Planning Authority Agenda

13 September 2022

5.1 Development Application DA 2022 / 00119 for Dwelling & Outbuilding (to be used as a Temporary Dwelling) at 7A Jordan Downs Drive, Brighton

Figure 4. Site plan

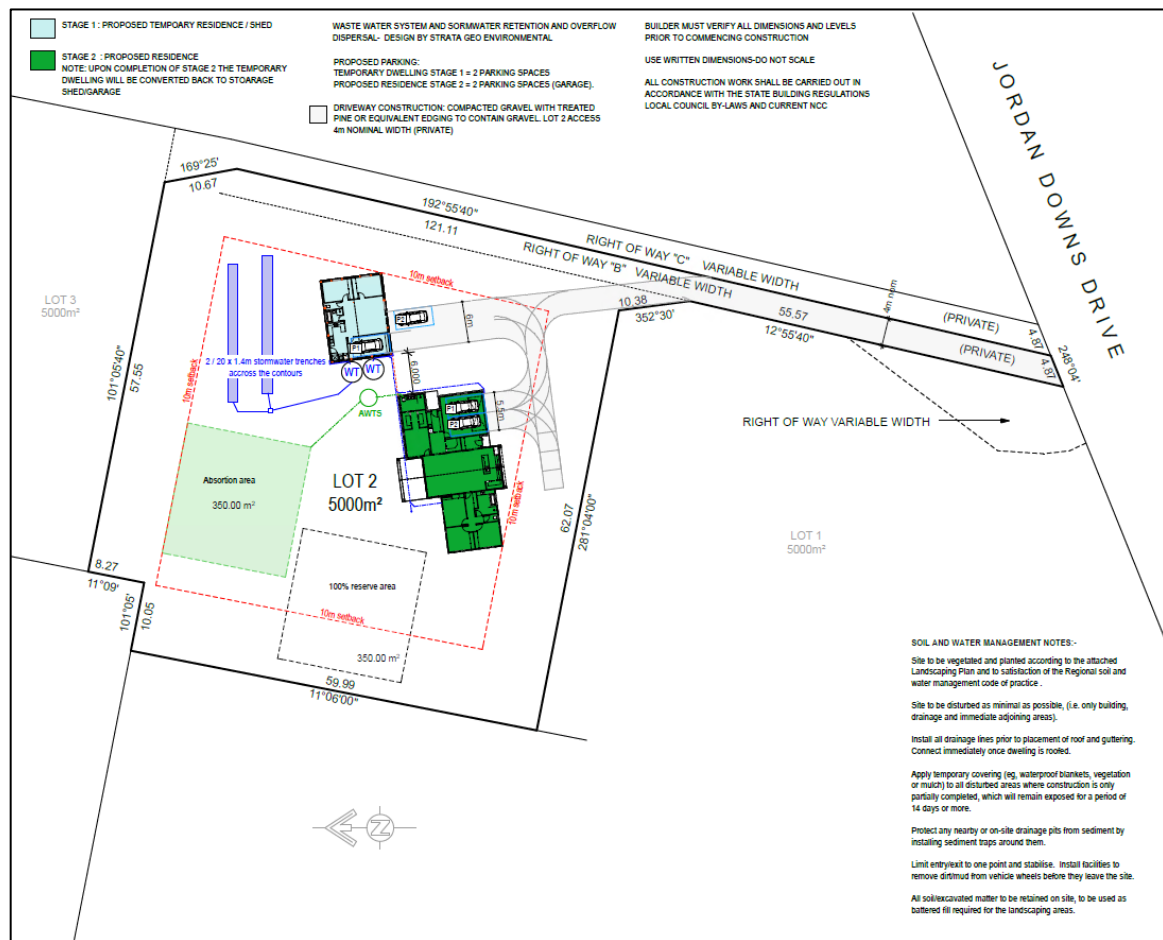
The buildings are separated by up to approx. 75m from the property's frontage, by up to 10m from a property's side or rear boundary, and by more than 200m from Agriculture or Rural-zoned land.

It is proposed that the driveway is surfaced with compacted gravel and has a minimum width of 4m.

The proposed driveway is surfaced with compacted gravel. Thus, the proposal does not meet the Acceptable Solution in clause C2.6.1 A1 and relies on the Performance Criteria in clause C2.6.1 P1.

The plans show that the driveway will be developed for the use of the proposed dwelling on site and, as such, the nature of the use is unlikely to create unreasonable vehicular traffic that requires the driveway to be sealed by any of the materials listed in clause C2.6.1 A1(c). Moreover, the site is relatively flat. Consequently, the proposed surface and topography significantly contribute to minimising the likelihood of stormwater running off to adjoining properties, debris or sediment being transported by vehicles from the driveway onto Jordan Downs Drive, or dust generation. It is recommended that the following conditions be included on any planning permit approved:

“The driveway must be drained to minimise surface runoff over adjoining land to the satisfaction of Council’s Municipal Engineer and in accordance with the requirements of the Building Act 2016.”; and

“The internal driveway and areas set-aside for parking and associated access and turning must be designed, constructed, and maintained to avoid dust or mud generation, erosion and sediment transfer off site or de-stabilisation of the soil on site or on adjacent properties to the standard required by Council’s Municipal Engineer.”
